1. To supplement Attachment B, please explain how SROG will monitor the pipeline between the Little Willow Facility and well DJS 2-14 to prevent leaks and/or spills.

2. *The application states on page 10 that a complete water flow testing and water analysis was done for two existing wells prior to developing the Willow Field. Data are presented for one of these two wells. To supplement Attachment E, provide the name, location, or value of Total Dissolved Solids for this other well.*

Figure 5-1: Index Map for Wells Sampling Water from Turbidite Sands at 1500'-2000' BGL

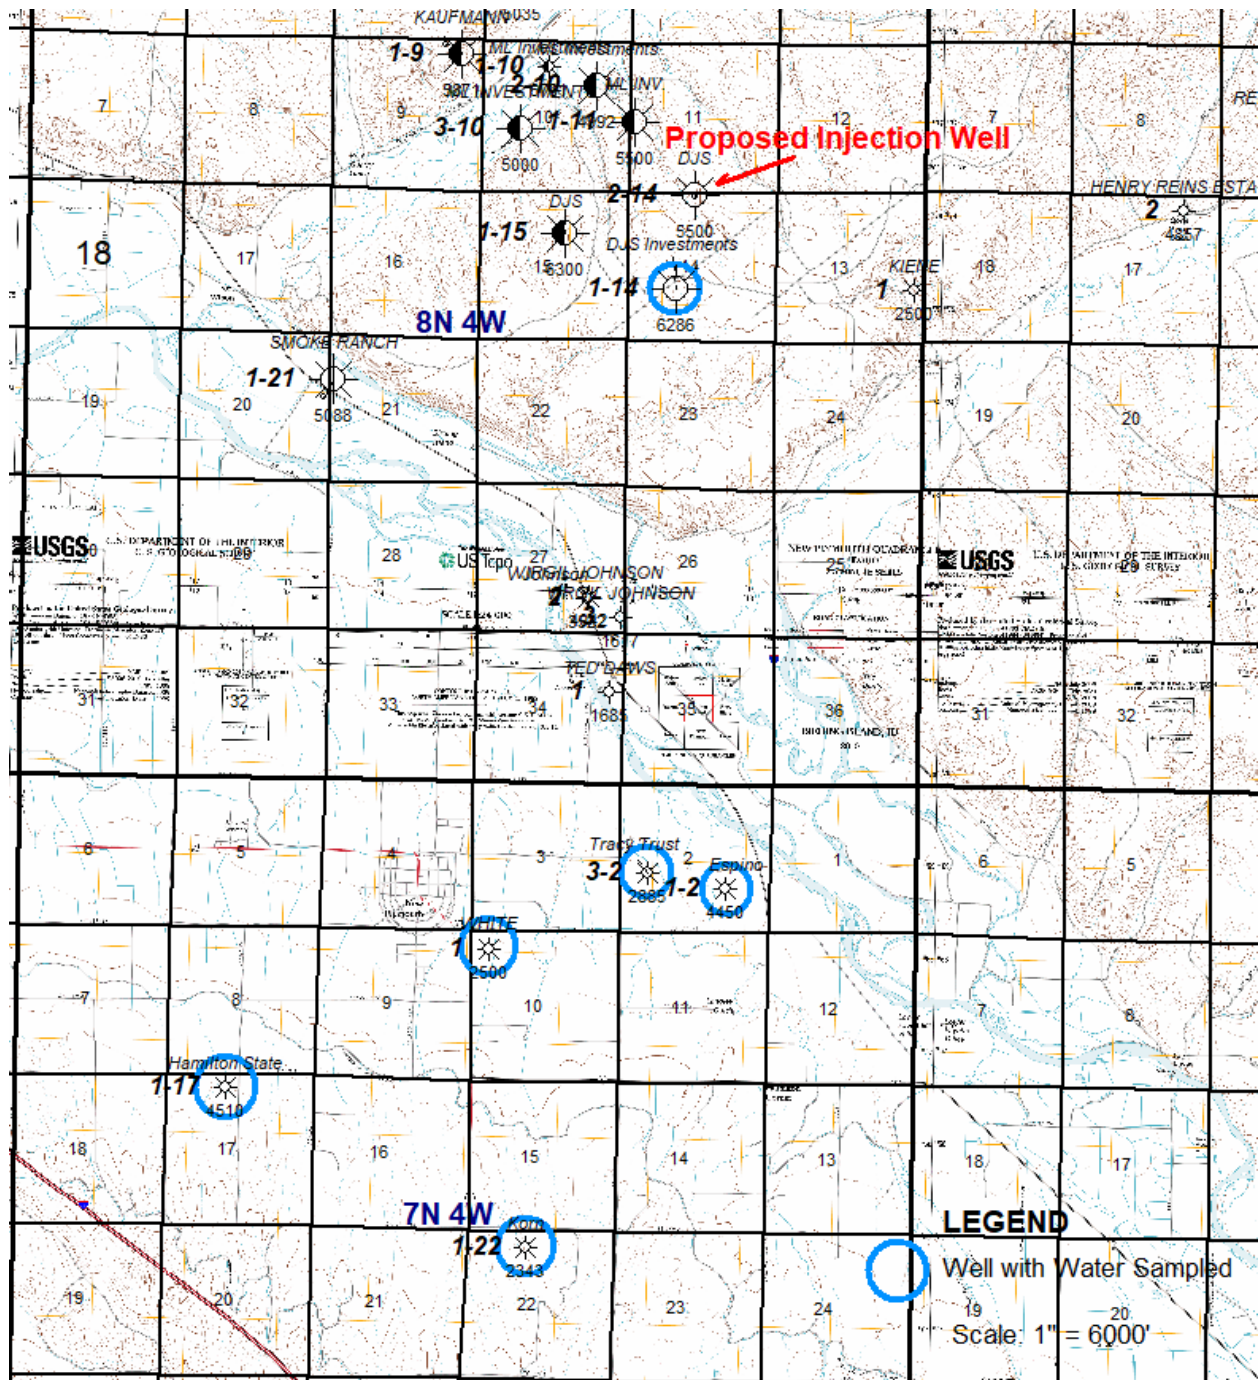
5. ***To supplement Attachment E, provide any previously-available water quality information on groundwater held within the turbidite sands situated between the Pierce Gulch Aquifer and the Willow Sands.***

There are six known wells in the greater project area that have sampled water from the sands between the Pierce Gulch Aquifer and the Willow Sands, found typically between 1500’ and 2000’ below ground level. All these wells were drilled as exploratory oil and gas tests. The water analyses for these wells are provided in the electronic folder in folder 5. An Index Map (Figure 5-1) showing the location of these wells and a Summary Table (Figure 5-2) listing the wells sampled are below:

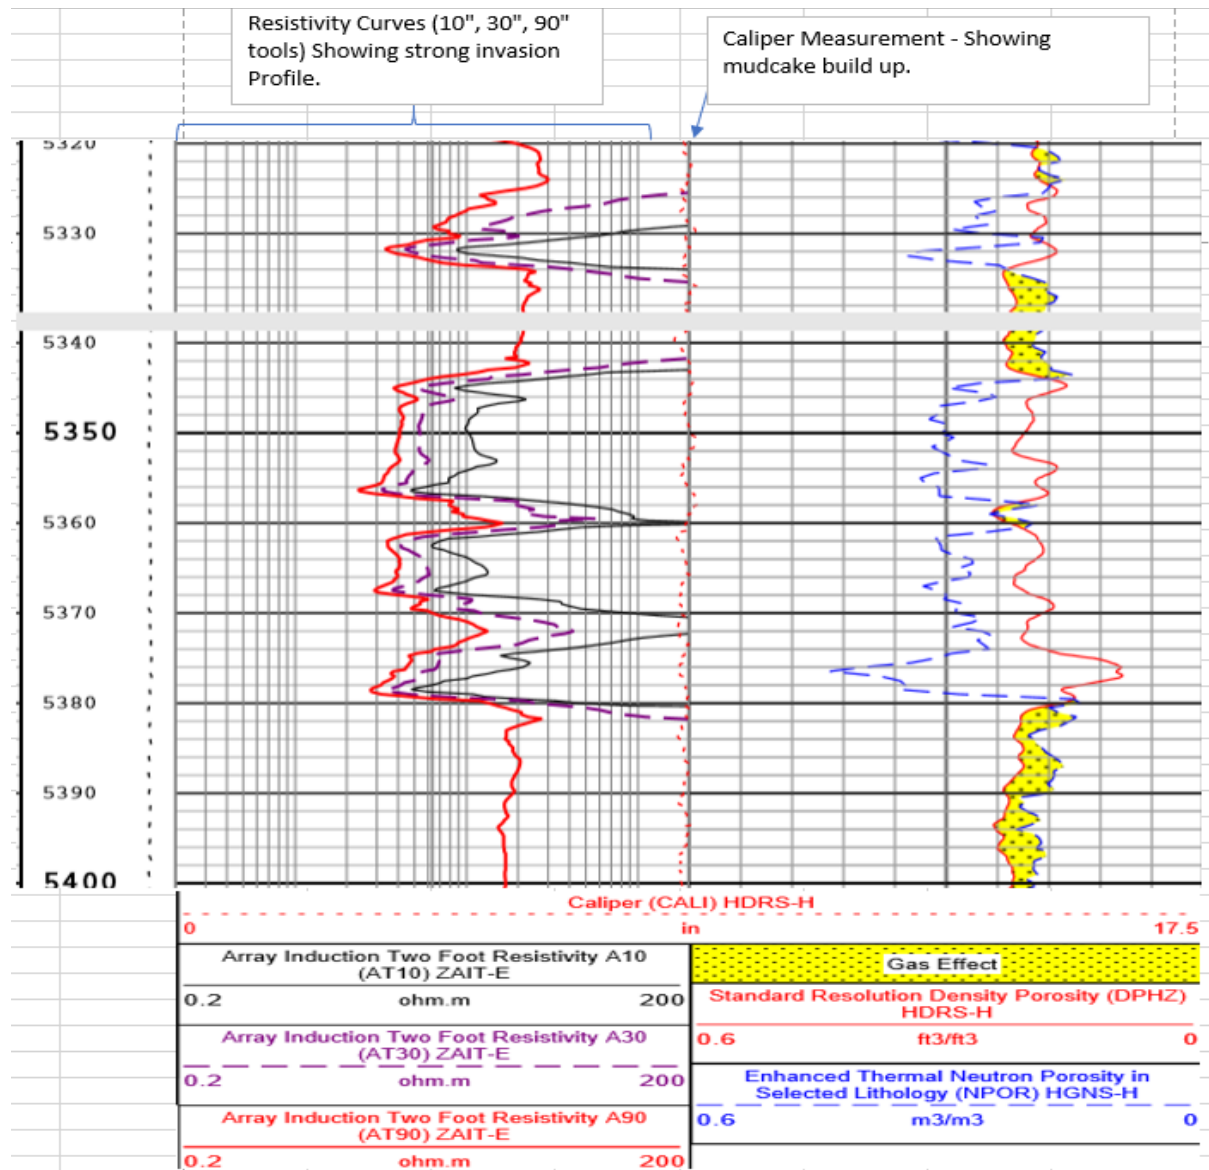
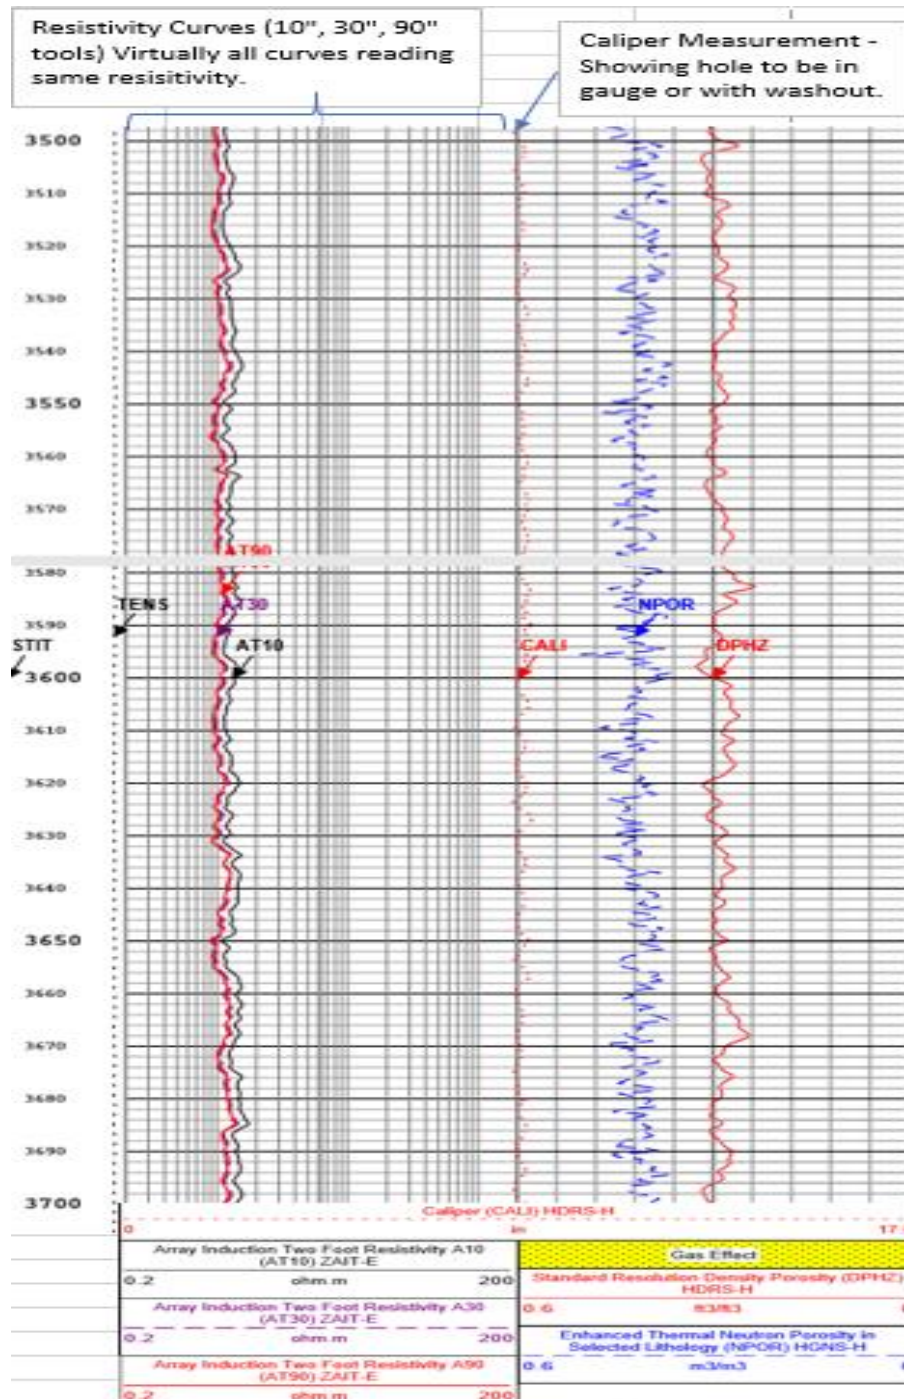
6. To Supplement Attachment G, provide calculated or estimated porosity and permeability data for the Chalk Hills claystone.

- a. The Chalk Hills Formation section in the DJS 2-14 wellbore, extends from 2,380' – 4,910' TVD. The most reliable data source that is available to determine both porosity and permeability within this shale/claystone section can be evaluated by viewing the core data that was obtained on 9/24/14 during the drilling of the DJS 2-14. Although core data can be adequate for determining various rock characteristics, SWC's, in general can often give slightly inflated results due to the nature in which they are recovered. At times, some shattering can occur while extracting the core and higher than normal permeability and porosity values are recorded.**

NOTE: The Chalk Hills log section above (200') should be fairly representative of the entire section itself. There is a minimum of 2,000' of shale/claystone above the Willow Sands that have the same consistent log characteristics in terms of the lithology nature, invasion profile, and mud cake.

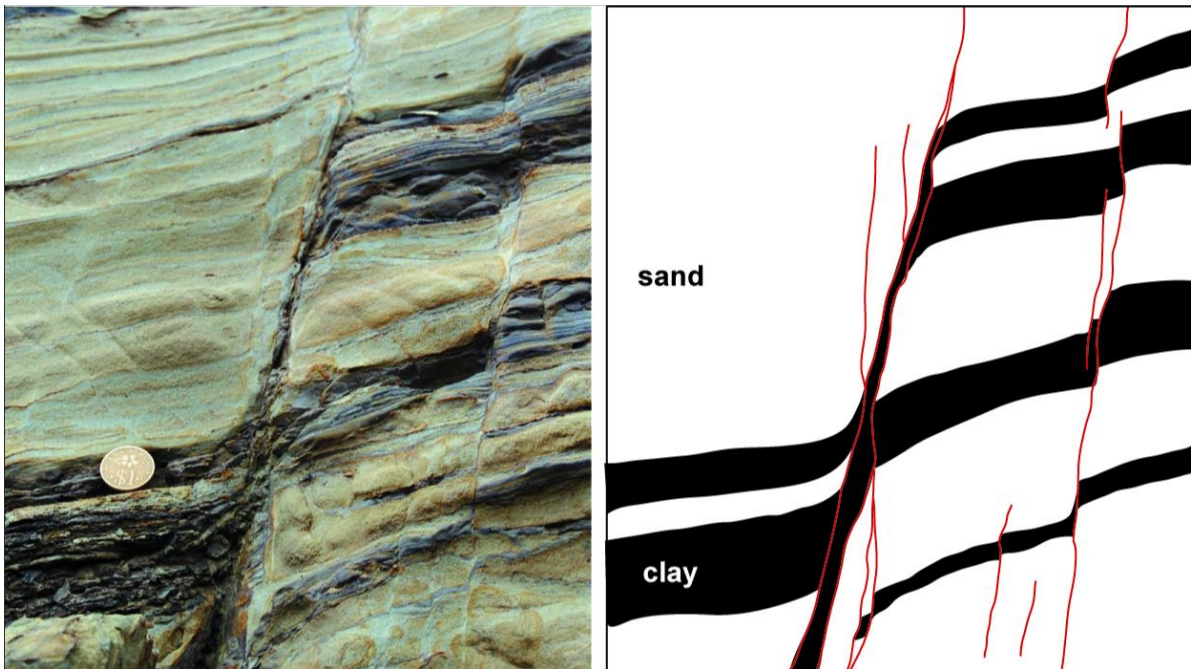
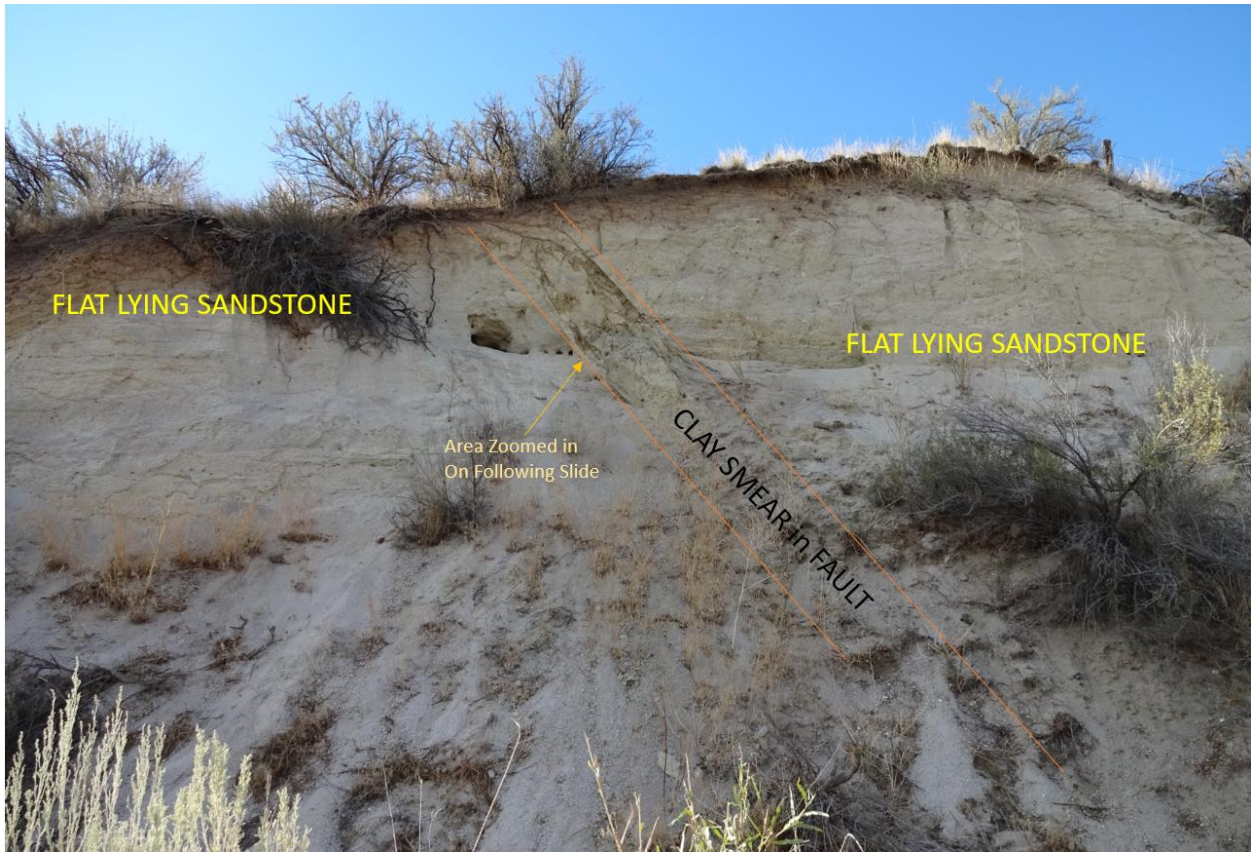
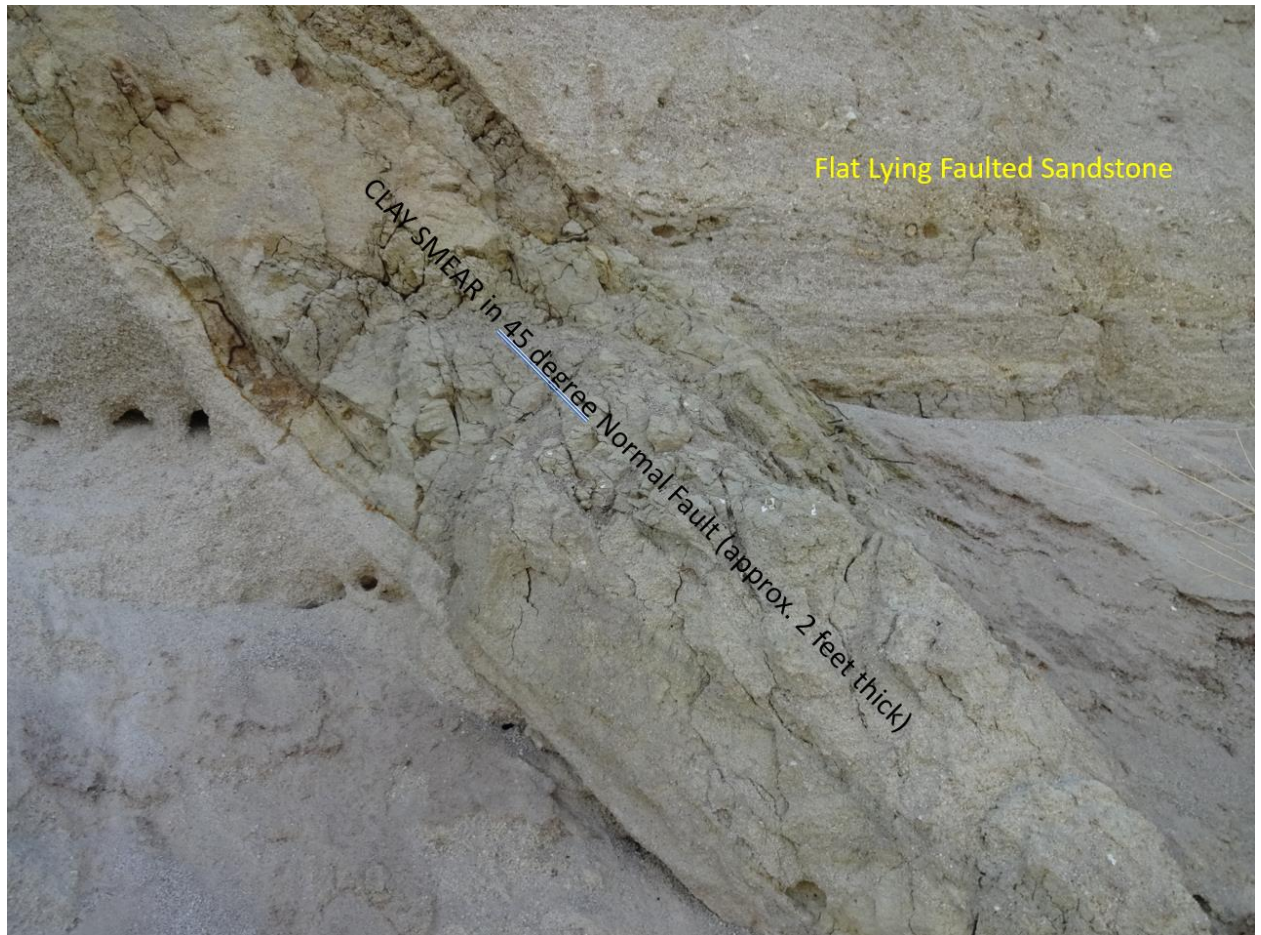
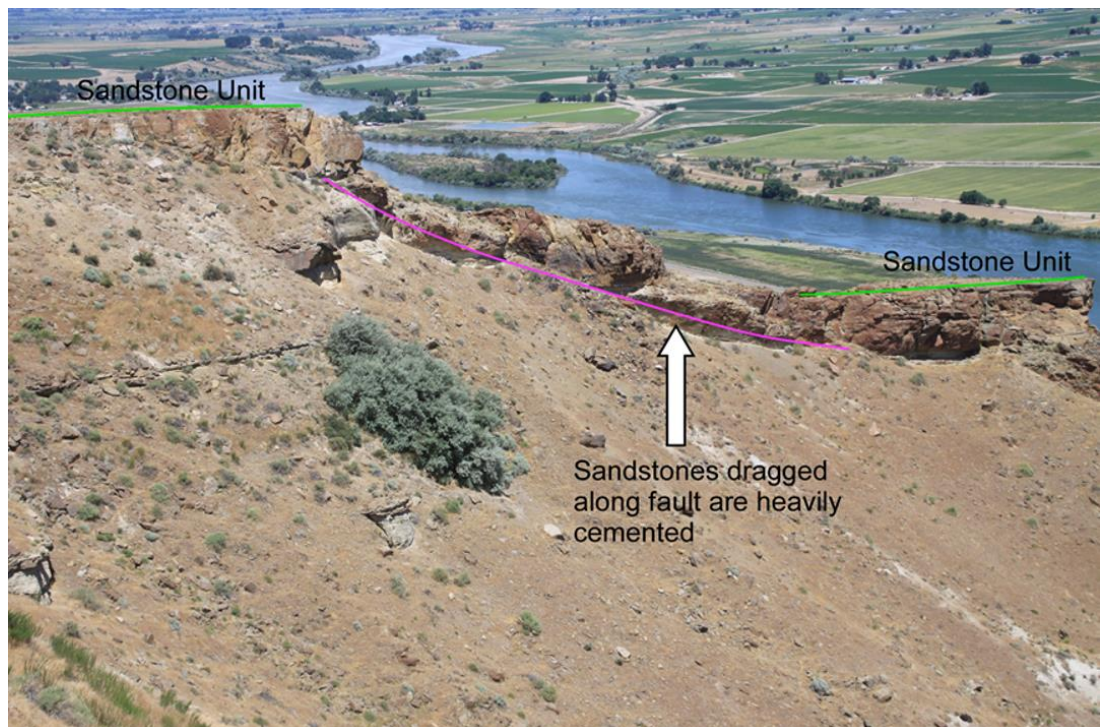
7. To supplement Attachment G, compare the sealing nature of faults across the region to the faults identified near the proposed injection zone. For example, are there faults with similar lithologies, ages, or degrees of offset in the general vicinity? Is there known information regarding possible diagenetic sealing? If this information is not available, please indicate as such.

A very large number of these types of faults observable in outcrops exhibit sealing behavior. Two of the most common sealing mechanisms are clay smear and silica cementation. Examples of both types are presented below, with outcrop photographs and discussion.

- a. Clay Smear: Clays are the dominant minerals in the widespread claystones found throughout the basin, above, below and often interbedded within the sandstones. They are very ductile minerals and are often drug along these extremely slow-moving, creeping type of sedimentary normal faults. They often form an extensive, relatively uniform sheet along a fault surface from a few inches to a few feet thick.

Another example of clay smear occupying a normal fault. In this instance the sands are flat lying on both sides of the fault, which is downthrown to the right. The clay smear is approximately 2 feet thick. Note the arrow in the center of the photograph, a closeup view of the clay smear within the fault is shown in the next figure. Note that some layers of the high porosity sands on either side of the fault are very friable, enough that birds have excavated small nest holes. However, the sands are competent and consolidated enough to form a small but sheer cliff face. This is a physical example that the sand beds are disposed to shear when exposed to a gradual extensional force, and that underlying claystones will bend and smear along the fault plane.

Note that the weakly consolidated sandstones on either side of the fault are flat lying. The clay layers composing the clay smear are aligned parallel with the fault plane at 45 degrees.
